## 4 Technical Review – Infeed Option

## 4.1 Muskrat Falls Generating Station

*Figure 9: Muskrat Falls and Labrador Island Link HVdc Interconnection (locations are approximate)*

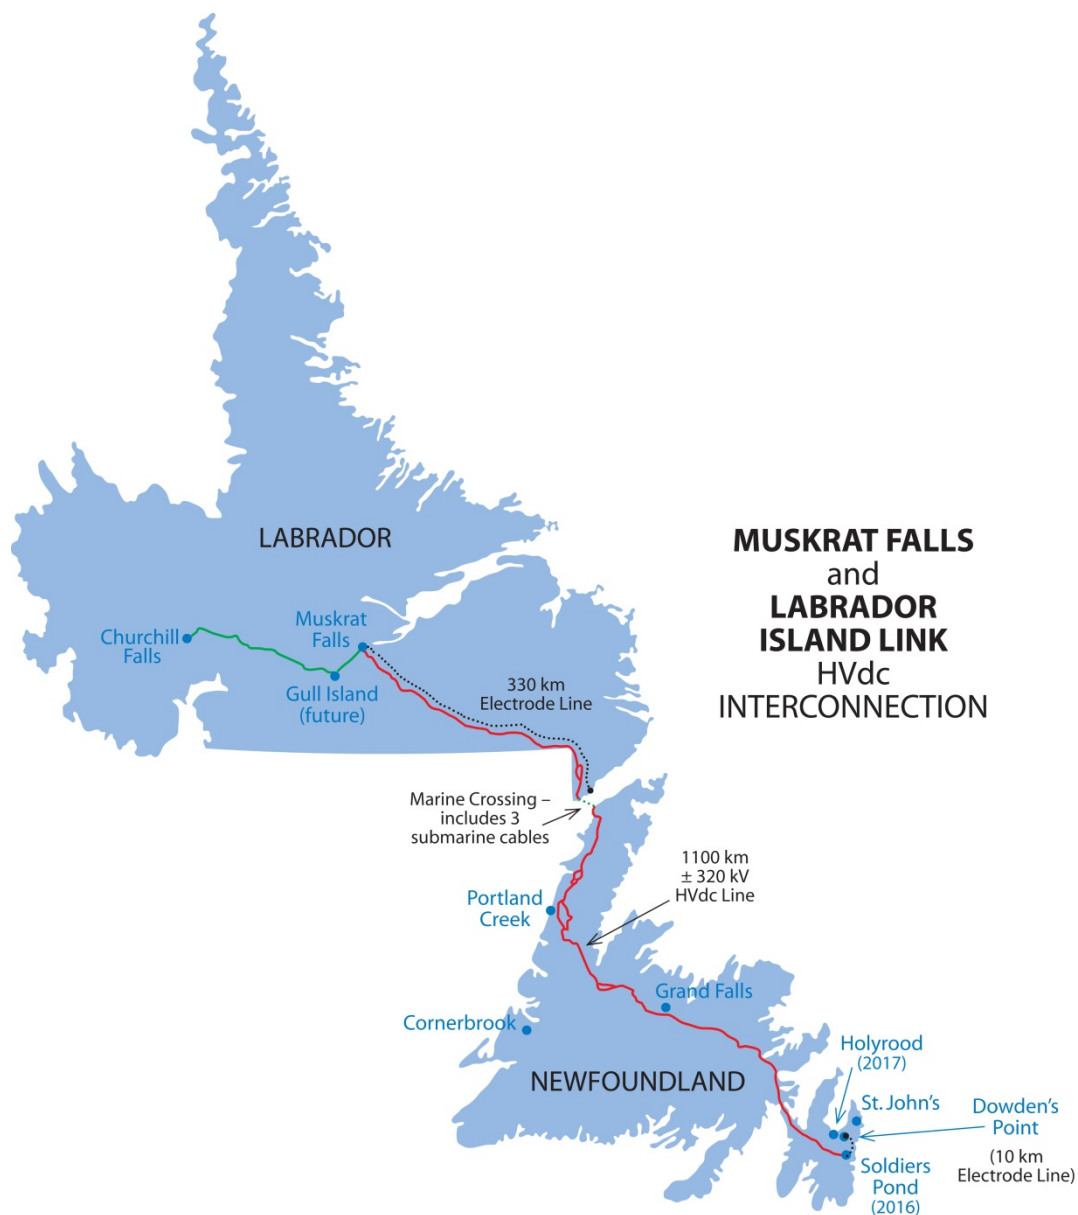
The Labrador-Island Link HVdc System, as shown in Figure 9 above, is a 900 MW  $\pm$ 320 kV bipolar system for point-to-point HVdc transmission. It is comprised of a 900 MW converter station at Muskrat Falls (1350 MW with a 150% overload capability), associated ac and dc switchyards, and 330 km of transmission lines to the Strait of Belle Isle. At the Strait, there will be a transition station to a marine crossing with three fully rated submarine cables, one a spare, and appropriate cable protection systems crossing the strait and landing on the island. On the island shore, there will be another transition station connecting to switching equipment and the overhead HVdc transmission line to Soldiers Pond Converter Station near St. John's. At Soldiers Pond, there will be both ac and dc switchyards and ac and dc filters, plus 3 - 300 MVar (volt-ampere reactive) high inertia synchronous condensers providing the required reactive support to successfully deliver the power to the island.

MHI notes that there was no comprehensive HVdc system risk analysis review for operations and maintenance for the overall HVdc transmission system including converter station equipment, transmission lines, or converter station control, protection and communications. MHI recommends that this operational design risk analysis be completed in conjunction with the development of the HVdc converter station specification so that any additional requirements may be included.

**Figure 10: Strait of Belle Isle Marine Crossing**

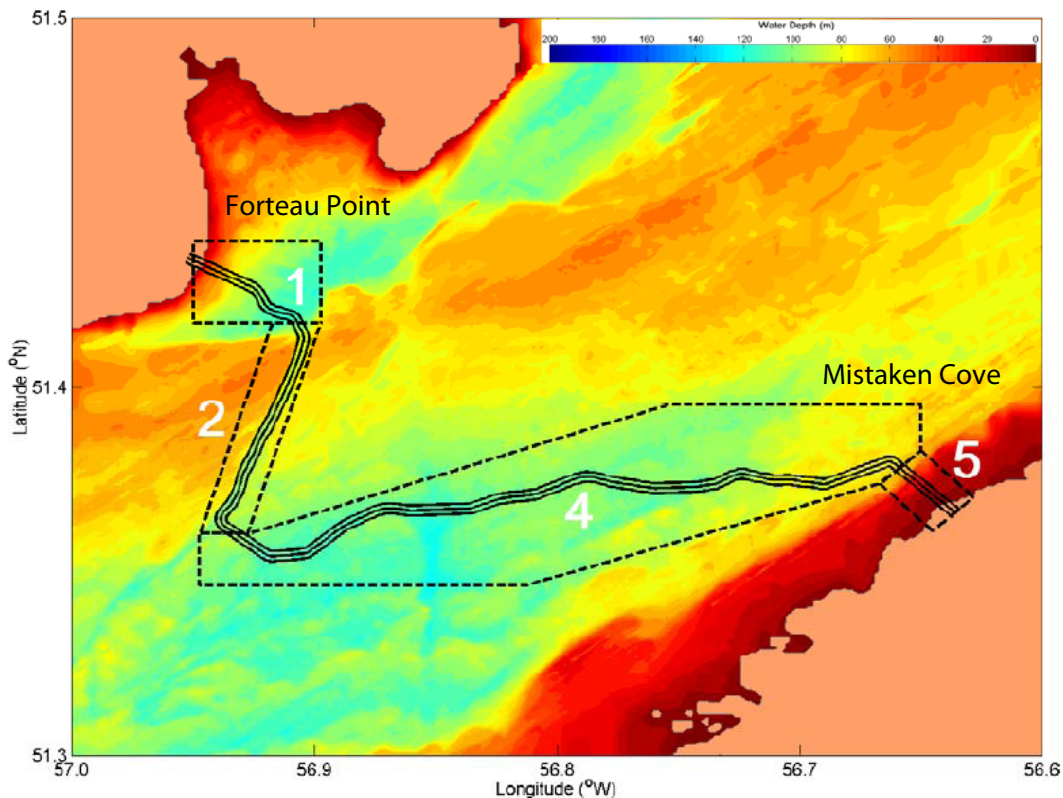
The cable corridor is shown below in Figure 10. This corridor takes into account the relevant landfall and possible protection methods. The estimated length is approximately 36 km, with roughly 32 km on the sea floor. The route is depicted within a 500-m-wide corridor with a 1500-m diameter circular

sea floor piercing target zone for horizontal directional drilling. Zone 3 is not shown but has been known as the Eastern Corridor and was not used due to the depth of water and potential for iceberg scouring.

MHI generally agrees with Nalcor's selection of the preferred alternative which included horizontal directional drilling as a means of shore approach for the cable and laying the cable on the seabed with a rock berm protection scheme. Nalcor's recommended design has been carefully formulated based on the synthesis of the conclusions reached in the various study documents.
